**CERTIFICATE OF APPROPRIATENESS**

**Property:** 305 E 5th Street, Tracts 13A &14A, Block 288, Houston Heights Subdivision. The property includes a historic 1,440 square foot, one-story wood frame single-family residence on a 6,600 square foot (66' x 100') corner lot.

**Proposal:** Alteration – Addition and alterations to the original structure:

**Recommendation:** Denial and issuance of a COR with a condition:

SITE/ROOF PLAN

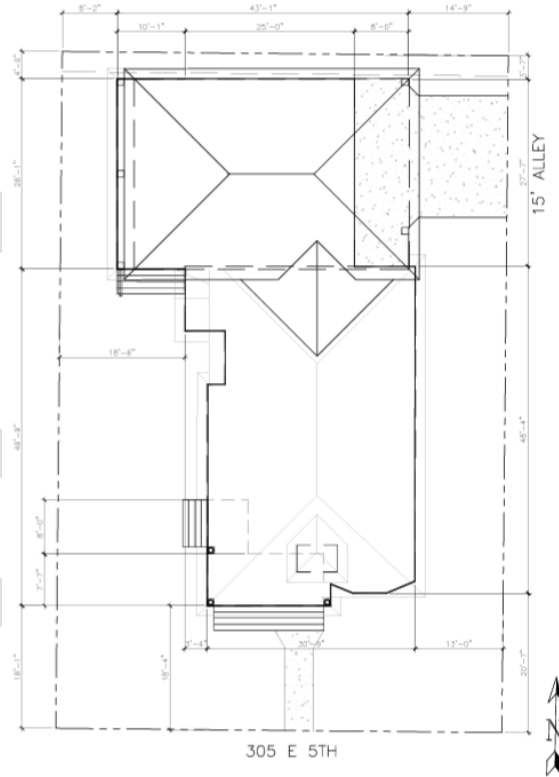
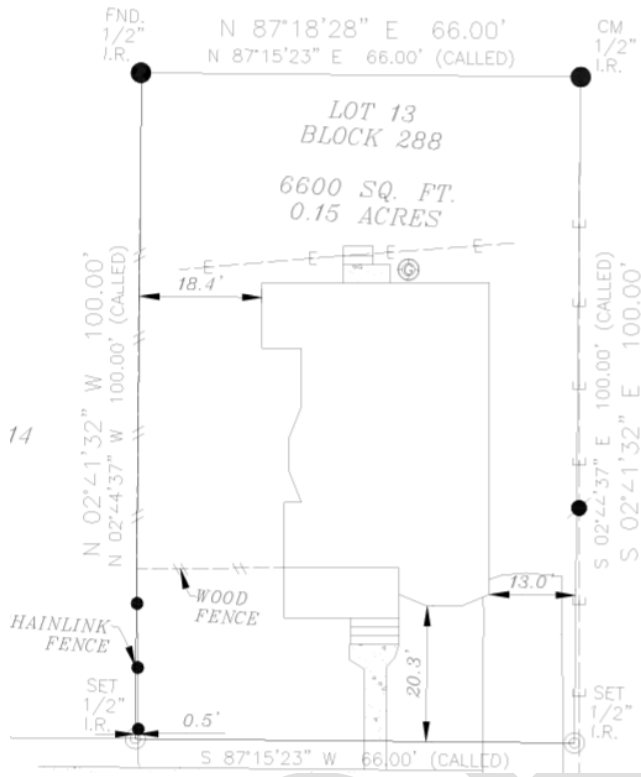
- The ridge height of the roof connecting the original house with the addition be lowered under the soffit of the addition.
- Brick skirting be vented, final design to be approved by staff.
